Daimler Truck North America LLC

Field Service Campaign

SF735 A

Adaptive Cruise Control (ACC): Cummins Medium Duty Engines

Fig. 1, ECM Parameters in Cummins INSITE

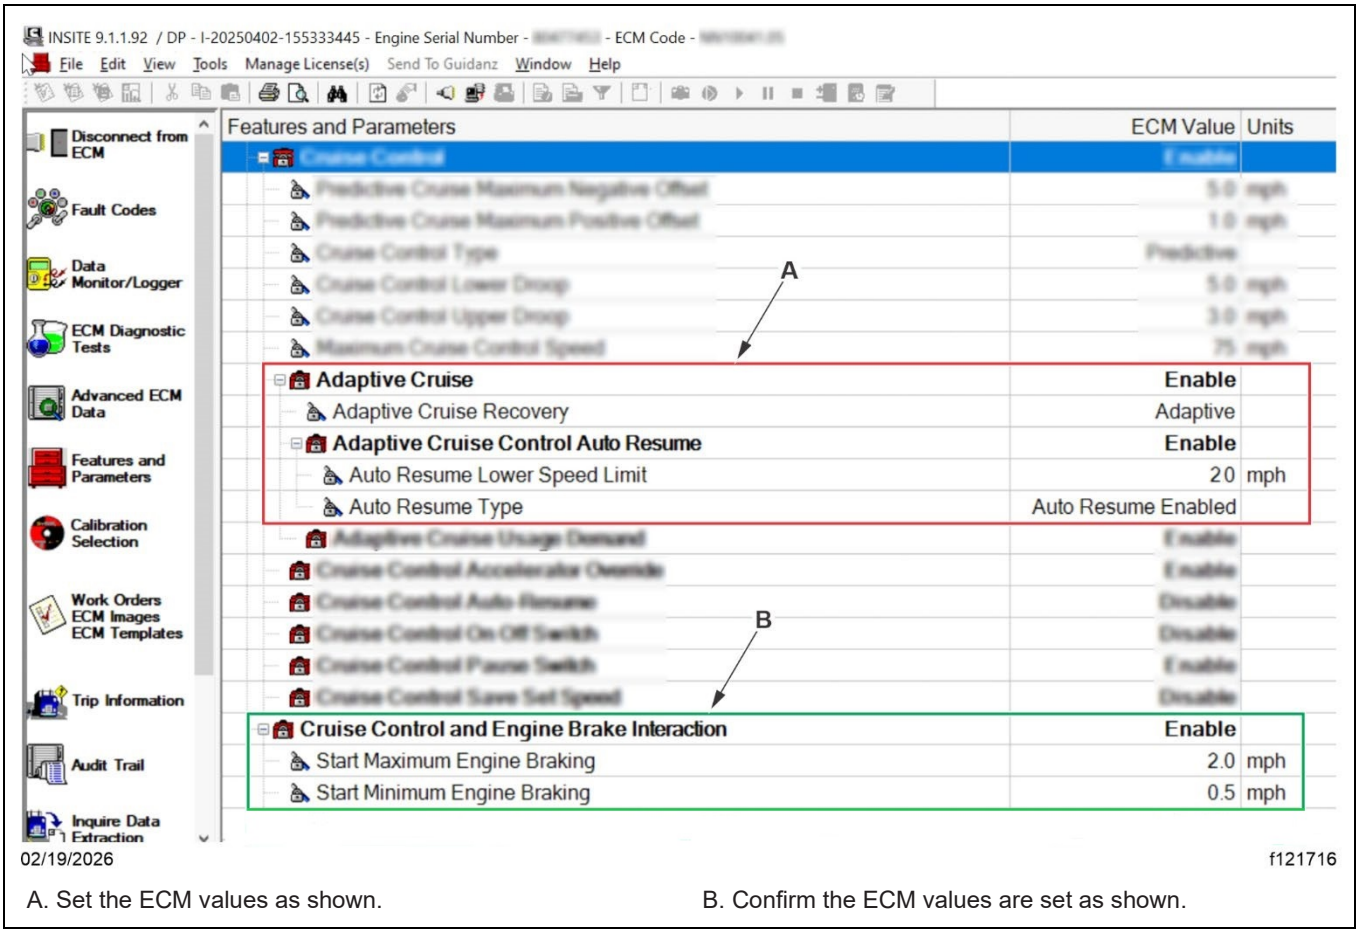
1. Check the base label (WAR259) for a completion sticker for SF735 (WAR261), indicating this work has been done. The base label is usually located on the passenger-side door, about 12 inches (30 cm) below the door latch. If a completion sticker is present, no work is needed. If a completion sticker is not present, proceed to the next step.
2. Park the vehicle on a level surface, shut down the engine, and set the parking brake. Chock the tires.
3. Connect to the Electronic Control Module (ECM) using Cummins INSITE™ or Guidanz®. Verify that the ECM is running the latest calibration. INSITE automatically checks for updates. The required software version is Rev. 19, which is the current release.
4. Set the ECM value for the 'Adaptive Cruise' parameters listed below. See **Fig. 1**.

5. For the engine brake performance to match the intended performance, confirm the ECM values for the 'Cruise Control and Engine Brake Interaction' parameters are set as listed below. See **Fig. 1**.

Features and Parameters	ECM Value
Adaptive Cruise	Enable
Adaptive Cruise Recovery	Adaptive
Adaptive Cruise Control Auto Resume	Enable
Auto Resume Lower Speed Limit	20 mph
Auto Resume Type	Auto Resume Enabled

Features and Parameters	ECM Value
Cruise Control and Engine Brake Interaction	Enable
Start Maximum Braking	2.0 mph
Start Minimum Braking	0.5 mph

A. Set the ECM values as shown.

B. Confirm the ECM values are set as shown.

Fig. 4, Setting the Adaptive Cruise Control Function Parameter Value

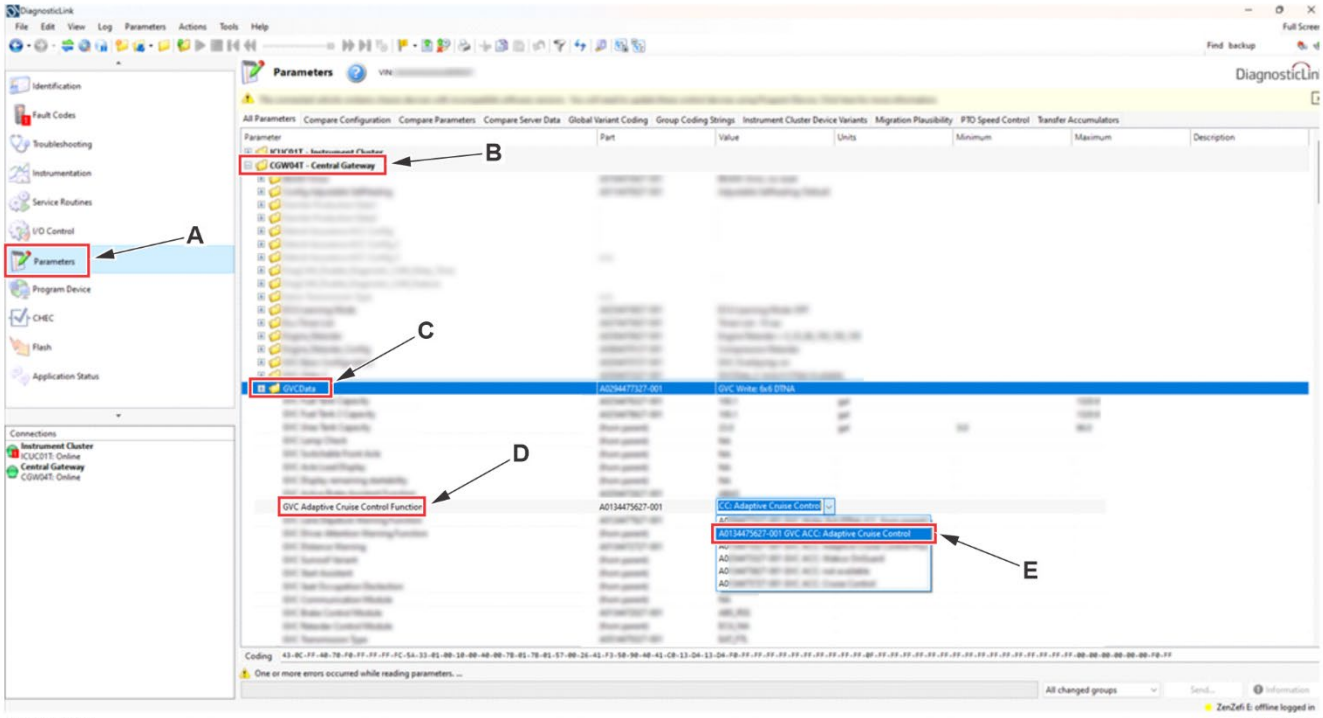
15. Go to the ‘Parameters’ tab. Select and expand the ‘CGW04T - Central Gateway’ parameter folder.
16. Select and expand the ‘GVCData’ parameter subfolder.
17. Select the ‘GVC Adaptive Cruise Control Function’ parameter, and set the parameter value to ‘A0134475627-001 GVC **ACC: Adaptive Cruise Control**.’ See **Fig. 4**.

A. Go to the ‘Parameters’ tab.
B. Select and expand the ‘CGW04T - Central Gateway’ parameter folder.
C. Select and expand the ‘GVCData’ parameter subfolder.
D. Select the ‘GVC Adaptive Cruise Control Function’ parameter.
E. Set the parameter value to ‘A0134475627-001 GVC ACC: Adaptive Cruise Control.’

Fig. 5, Setting the Distance Warning Parameter Value

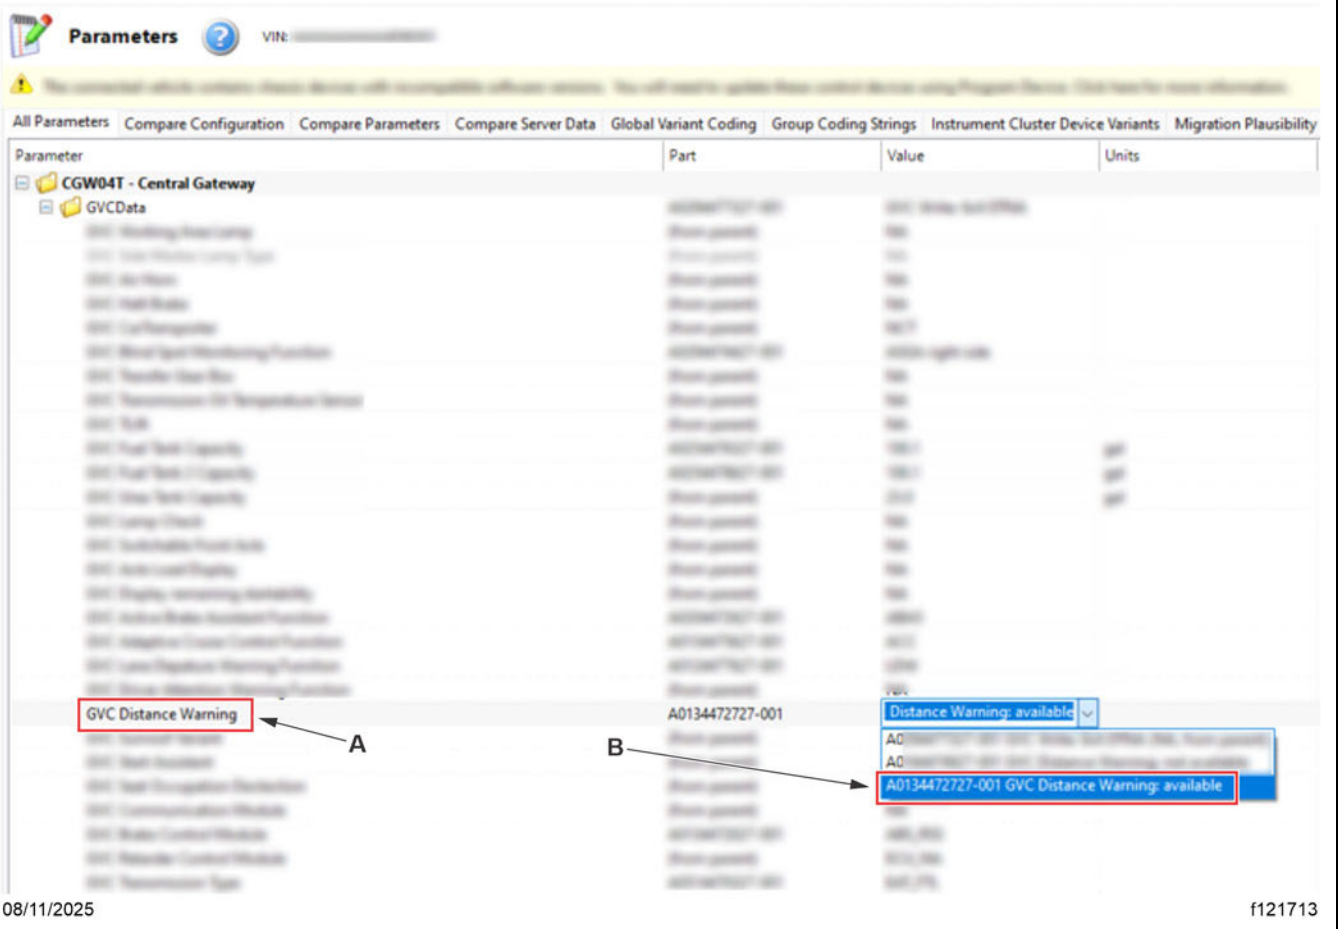
18. Select the ‘GVC Distance Warning’ parameter, and set the parameter value to ‘A0134472727-001 GVC Distance Warning: **available**.’ See **Fig. 5**.

A. Select the ‘GVC Distance Warning’ parameter.
B. Set the parameter value to ‘A0134472727-001 GVC Distance Warning: available.’

Fig. 6, Setting the paramCCBackUp Parameter Value

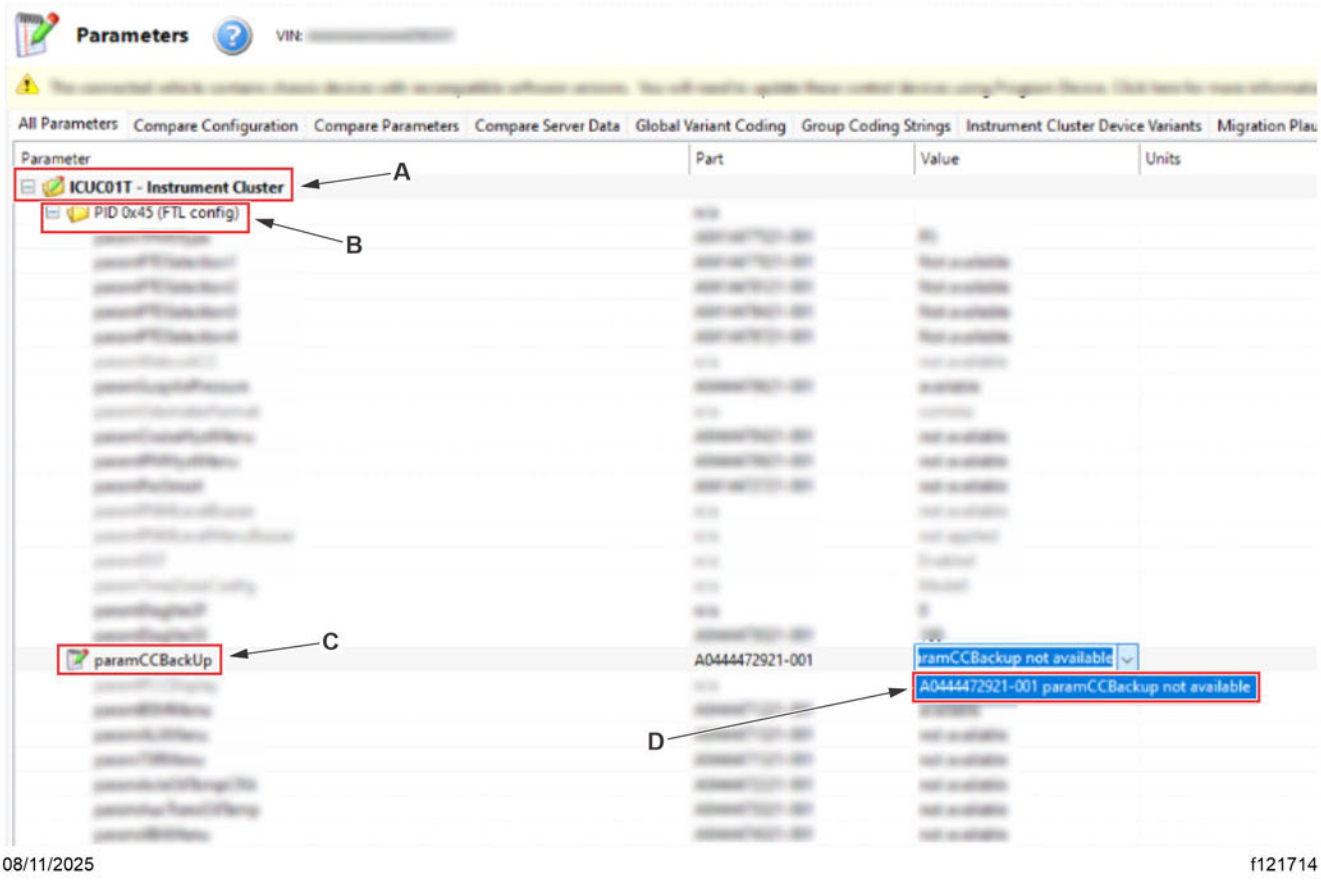
19. Select and expand the ‘ICUC01T - Instrument Cluster’ parameter folder.
20. Select and expand the ‘PID 0x45 (FTL config)’ parameter subfolder.
21. Select the ‘paramCCBackUp’ parameter, and set the parameter value to ‘A0444472921-001 paramCCBackUp paramCCBackup **not available**.’ See **Fig. 6**.

A. Select and expand the ‘ICUC01T - Instrument Cluster’ parameter folder.
B. Select and expand the ‘PID 0x45 (FTL config)’ parameter subfolder.
C. Select the ‘paramCCBackUp’ parameter.
D. Set the parameter value to ‘A0444472921-001 paramCCBackUp paramCCBackup not available.’

Fig. 7, Setting the paramDASMenuHysteresis Parameter Value

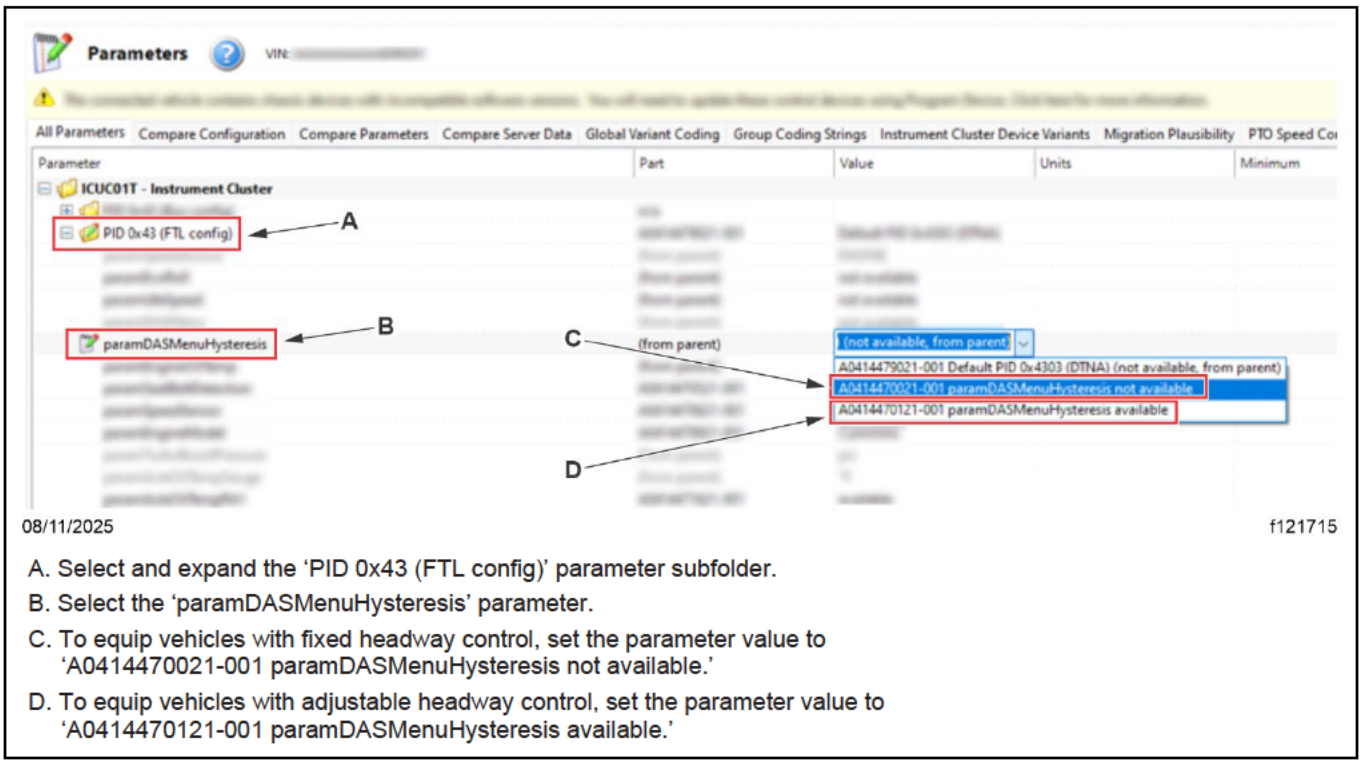
22. Select and expand the 'PID 0x43 (FTL config)' parameter subfolder, and select the 'paramDASMenuHysteresis' parameter. Based on the customers preference, set the parameter value as listed below. See **Fig. 7**.

Vehicles Equipped with ..	Parameter Value
Fixed Headway Control	A0414470021-001 paramDASMenuHysteresis not available
Adjustable Headway Control	A0414470121-001 paramDASMenuHysteresis available

A. Select and expand the 'PID 0x43 (FTL config)' parameter subfolder.
B. Select the 'paramDASMenuHysteresis' parameter.
C. To equip vehicles with fixed headway control, set the parameter value to 'A0414470021-001 paramDASMenuHysteresis not available.'
D. To equip vehicles with adjustable headway control, set the parameter value to 'A0414470121-001 paramDASMenuHysteresis available.'
